**INVITATION FOR BIDS
Westwood High School Practice Field
Bid # DPW-22-B-023
Addendum 01
March 30, 2022**

Westwood High School Practice Field Renovation

ADD ALTERNATE DETAILS PLAN 1

SHEET NO. 01b
 APPENDUM 01b
 REPLACES SHEET 8

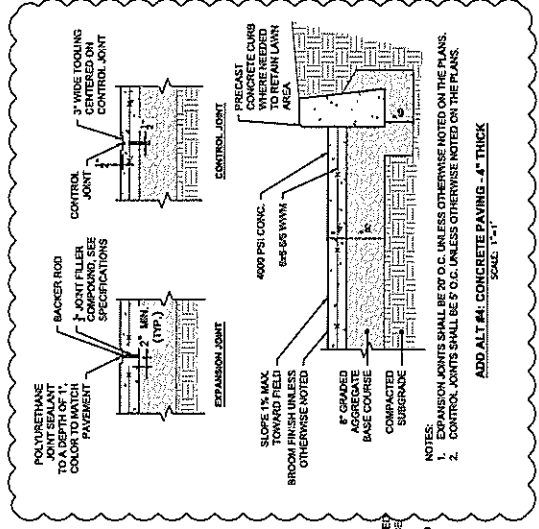
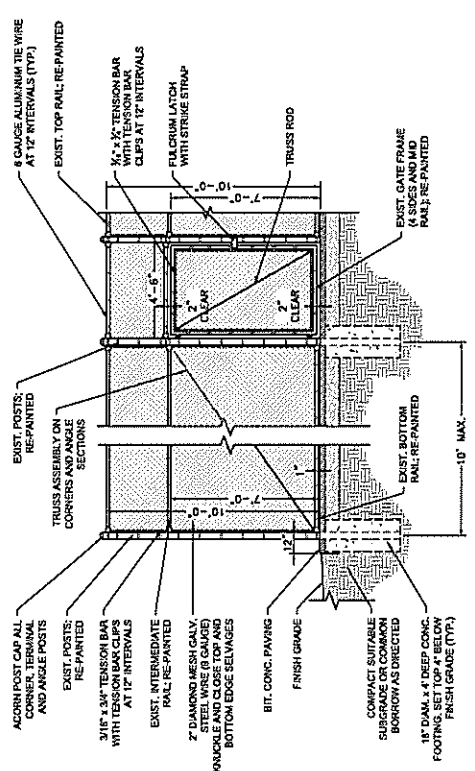
- Q2 How will the grade be handled at the back of the concrete pads (Add Alternate #4) where it will end up above the grade of the concrete pad?
A2 Where the grade at the back of the concrete pad is less than 6", the grade should be gently sloped to meet the existing lawn area and re-seeded. Where the grade at the back of the concrete pad is 6" or more, a pre-cast concrete curb shall be used to retain the grade. See Addendum 01b (former sheet 8 in bid set).

- Q3 How should the concrete pads be pitched for drainage (Add Alternate #4)?
A3 The concrete pads should be pitched a minimum of 1% towards the track due to the grades of the lawn area. See Addendum 01b (former sheet 8 in bid set).
